CALVERT CLIFFS NUCLEAR POWER PLANT UNIT NO. 1

Amendment No. 96
License No. DPR-53

CALVERT CLIFFS NUCLEAR POWER PLANT UNIT NO. 2

SUPPORTING AMENDMENT NOS. 96 AND 77

FIGURE 6.2-1
 MANAGEMENT ORGANIZATION CHART
 CALVERT CLIFFS NUCLEAR POWER PLANT
 BALTIMORE GAS & ELECTRIC COMPANY

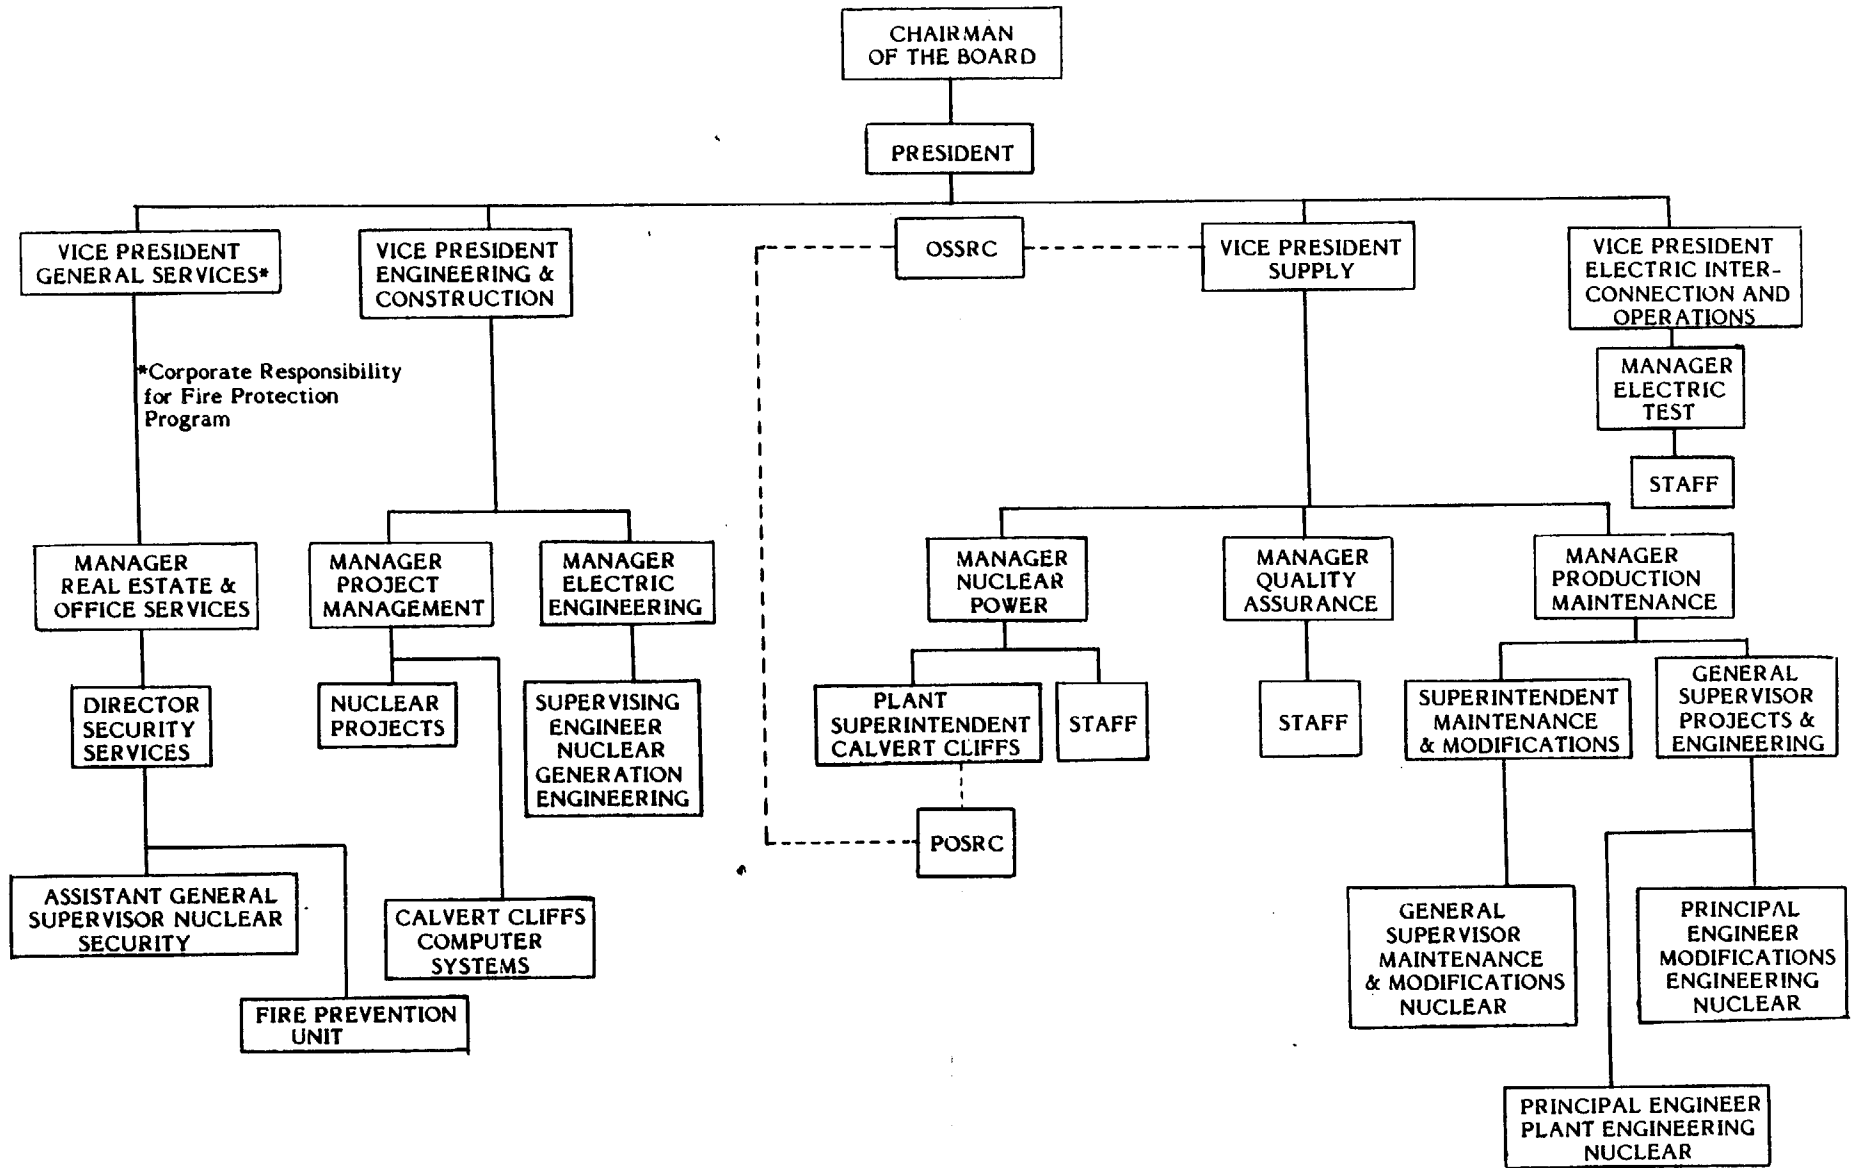
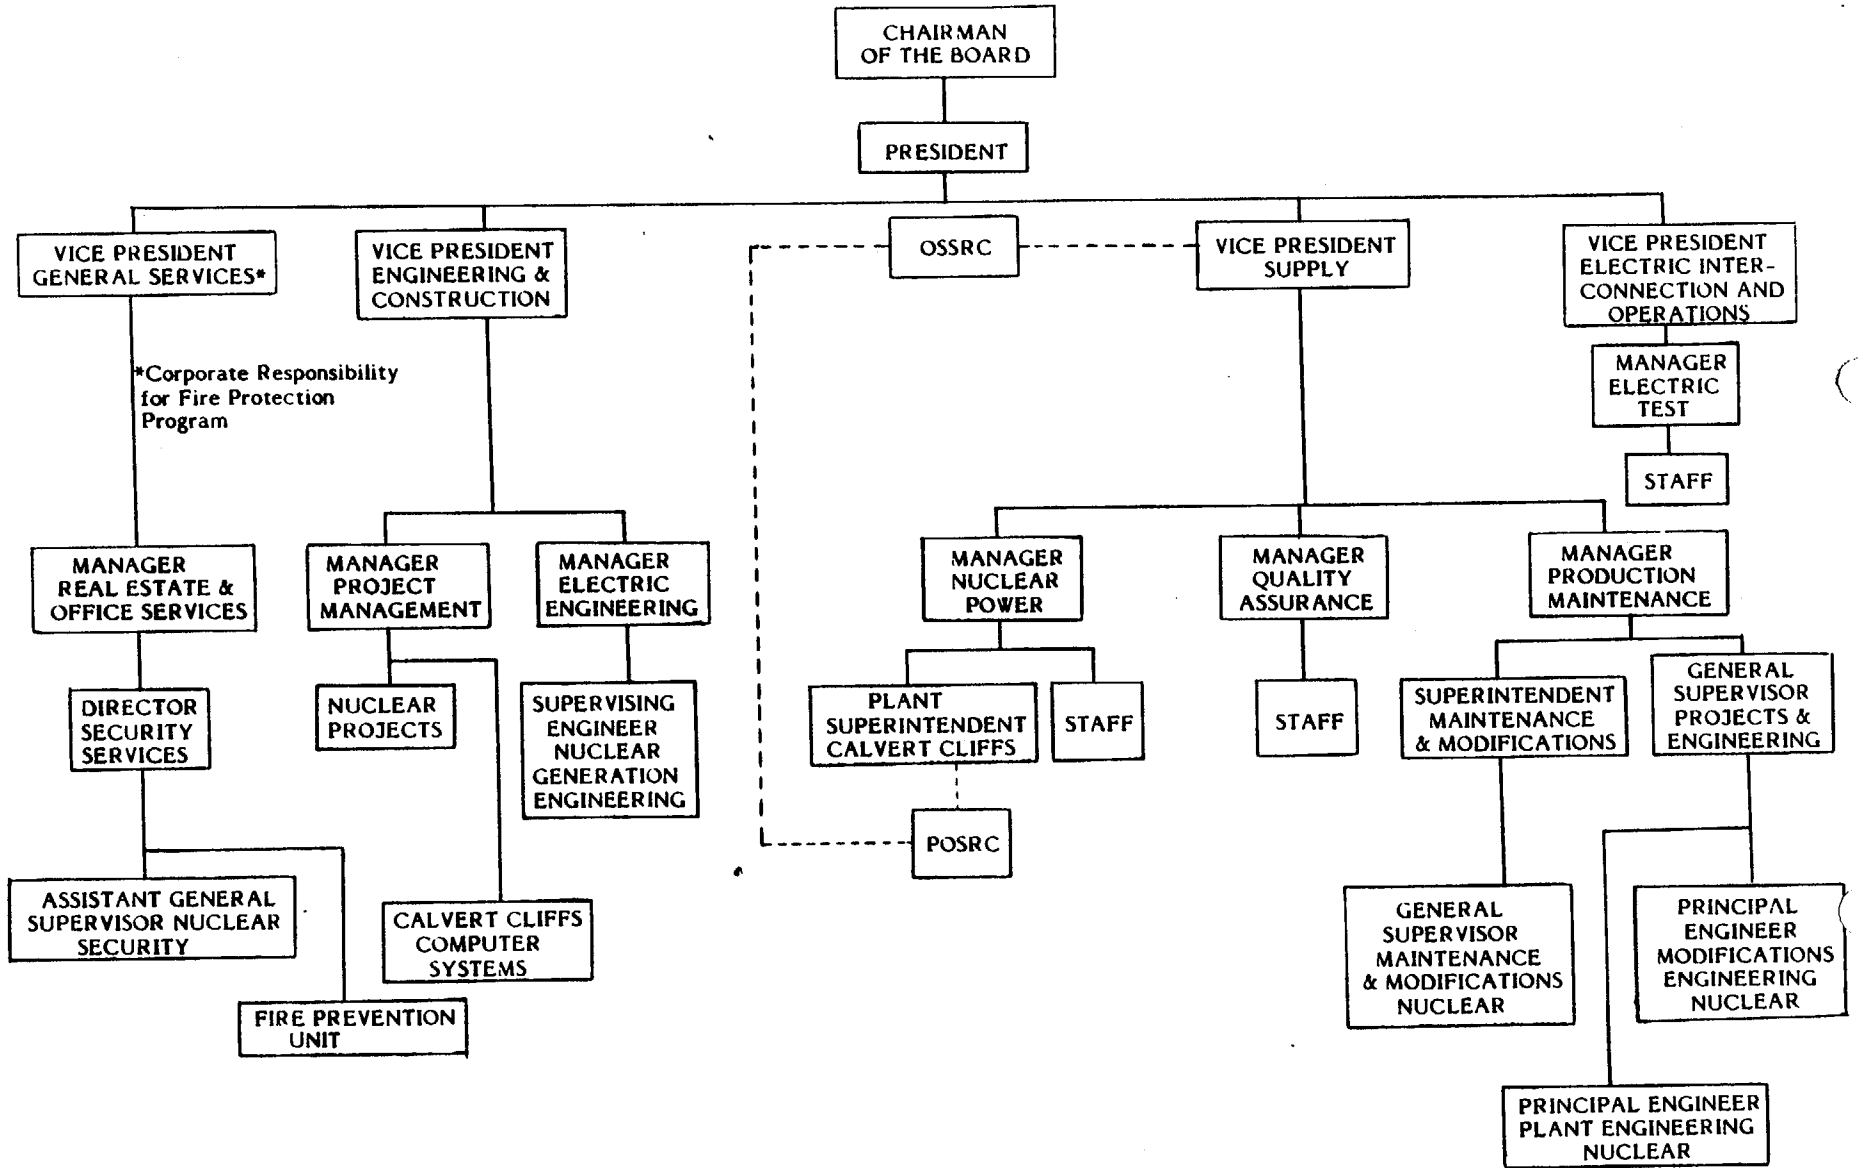
The second proposed modification would change the corporate responsibility for the BG&E Fire Prevention Unit as shown in TS Figure 6.2-1. The Fire Prevention Unit, which originally reported to the General Supervisor-Finance, now reports to the Manager-Real Estate and Office Services. Because of this organizational responsibility shift, the corporate responsibility for the Fire Protection Program is now assigned to the Vice President-General Services.

In both the proposed changes to TS 6.2, the safety functions of the individual or organizational units involved have not been changed and therefore the proposed changes are only administrative in nature. Accordingly, the proposed changes to TS 6.2 are acceptable.

Figure 6.2.2
Organization Chart (Two Unit Operation) - Calvert Cliffs Nuclear Power Plant
Baltimore Gas and Electric Company

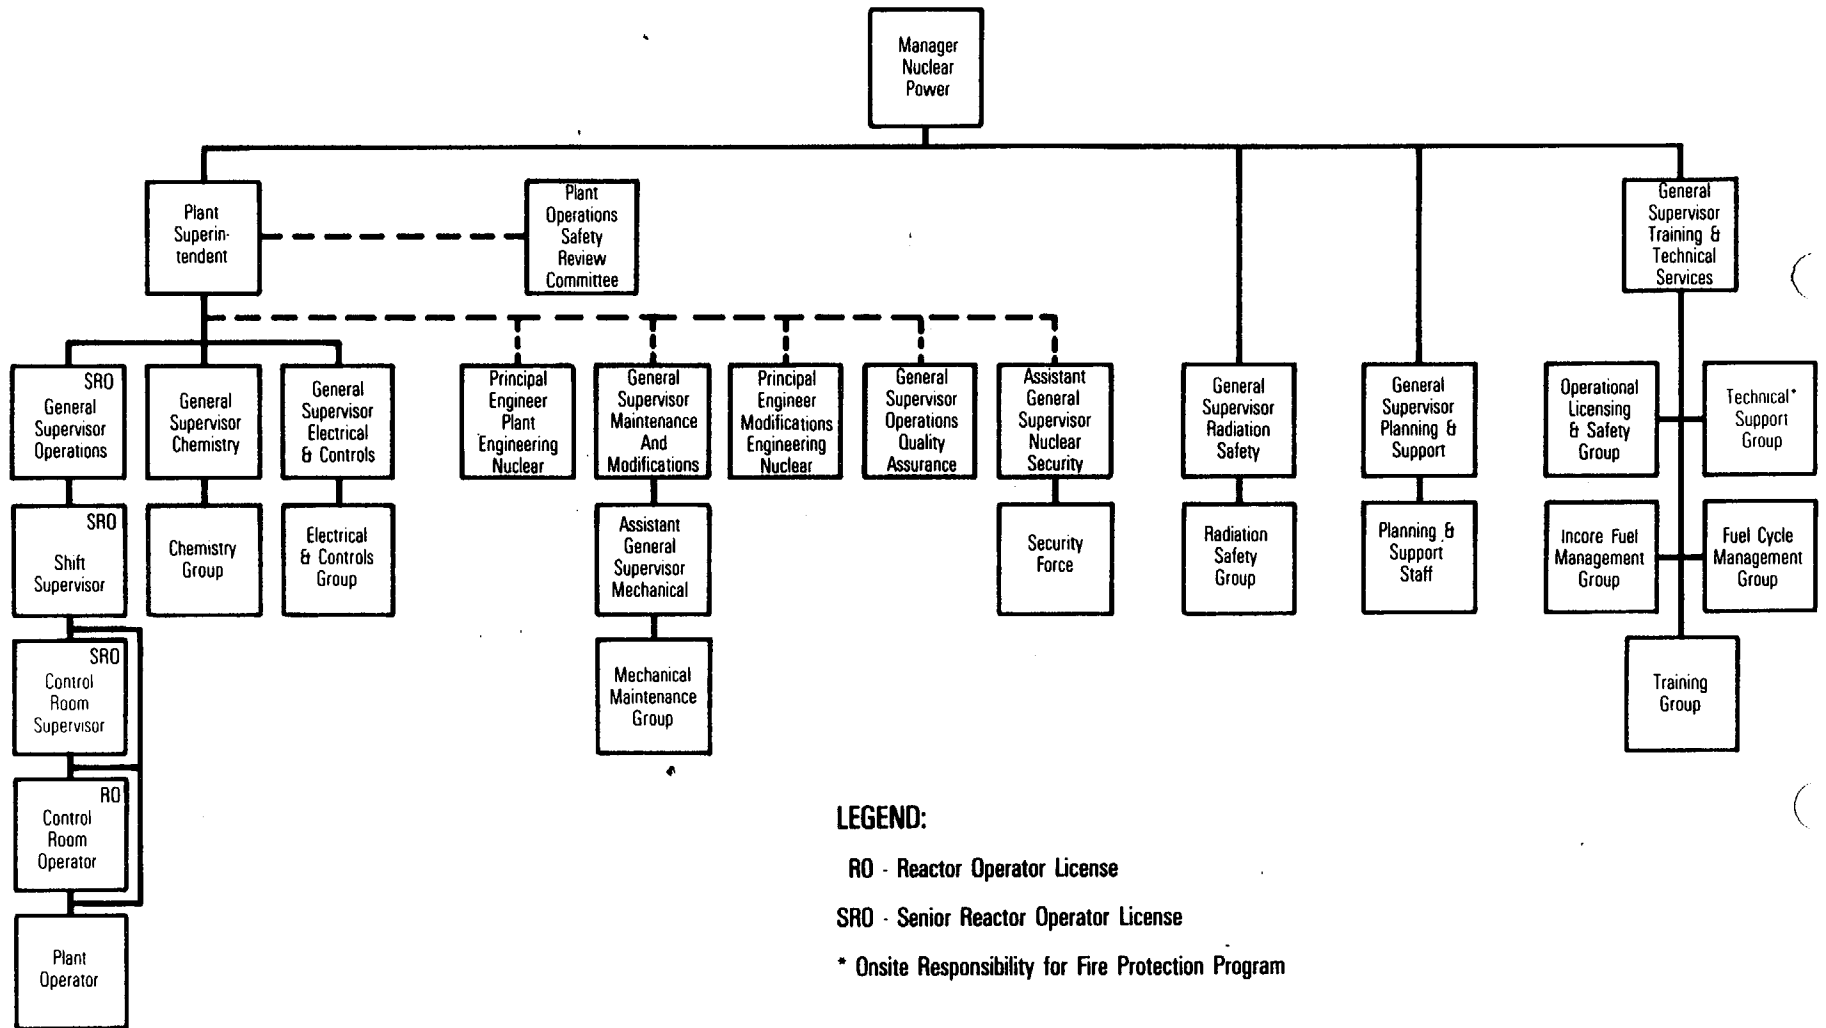
BG&E has proposed two changes to the organizational requirements of TS 6.2, "Organization". The first modification would change the title of the "Senior Control Room Operator" (SCRO) to "Control Room Supervisor" in TS Figure 6.2.2. This change is necessary to distinguish the SCRO who is on duty in the control room, who will be referred to as the Control Room Supervisor, from other SCROs who may be assigned to other duties at the facility.
